## ASOS MODIFICATION NOTE 60 (for Electronics Technicians)

SUBJECT : Acquisition Control Unit (ACU) Memory Erasable Programmable Read Only Memory (EPROM) Firmware Version 2.50

Data Collection Package (DCP) Boot EPROMs Firmware Version 1.80

PURPOSE : Time Critical Firmware Upgrade for the Automated Surface Observing System (ASOS) Operational Load. **Installation must be completed on or before November 4, 1998.**

FIGURE 1

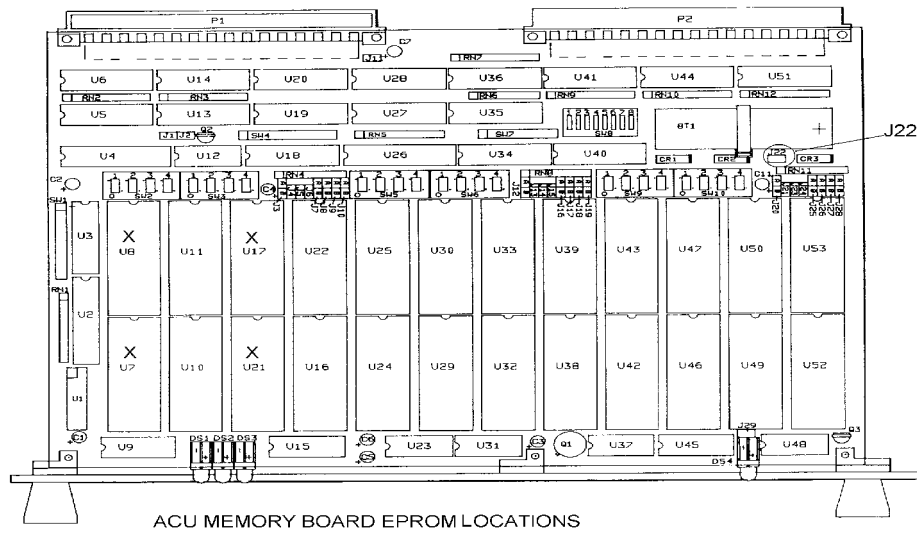
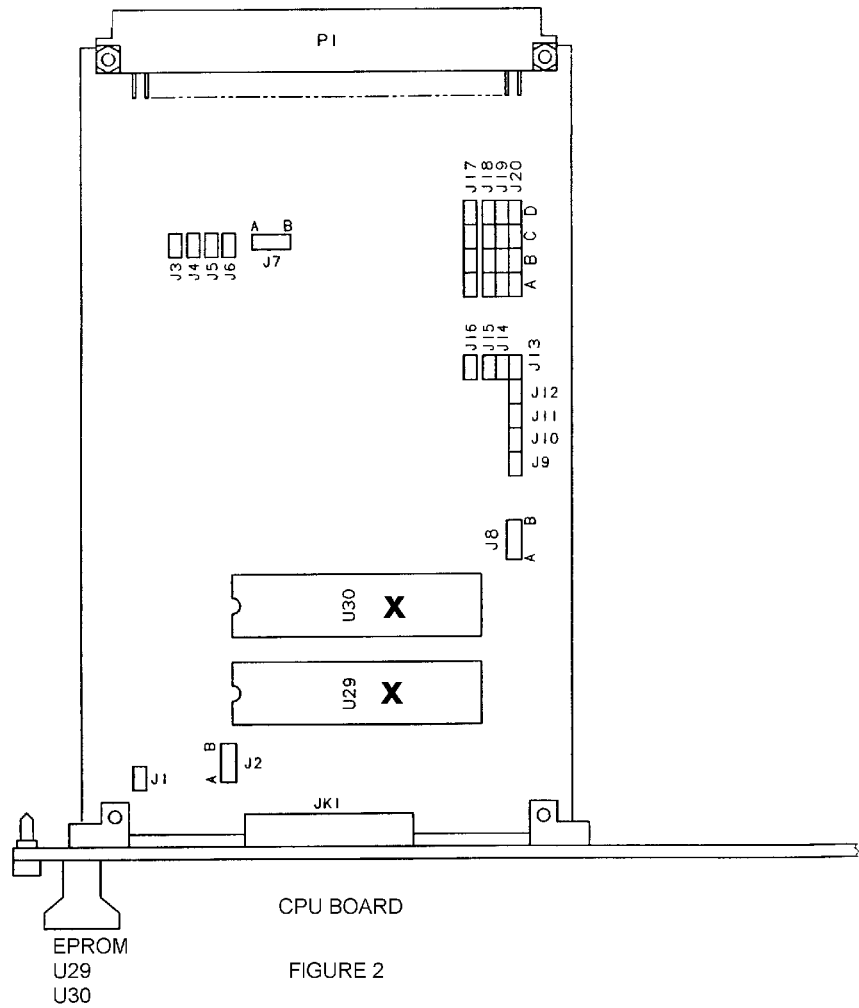
All ASOS application software is contained on the four EPROM IC on ACU memory board 1A2A3. Figure 1 illustrates the ACU memory board and identifies the four EPROMs (U7, U8, U17, and U21) to be replaced. Figure 2 illustrates DCP memory board 2A1A2A1 and/or 2A1A2A2 and identifies EPROMs (U29 and U30) to be replaced. The EPROMs are 32-pin dual in-line package CMOS devices, each providing 512K x 8 bits of storage. Upgrading ASOS software requires only replacing the four EPROMs on the ACU memory board with a higher revision level of ICs.

10. Remove the new EPROM ICs from the protective package and insert them into the memory board sockets in accordance with the following chart. Ensure that the EPROMs are installed with pin 1 (as identified by the notch in top of IC) oriented toward board connectors P1 and P2 as shown on figure 1.

<u>IC socket</u>	<u>IC part number</u>
U7	62828-45004-1
U8	62828-45002-1
U17	62828-45003-1
U21	62828-45005-1
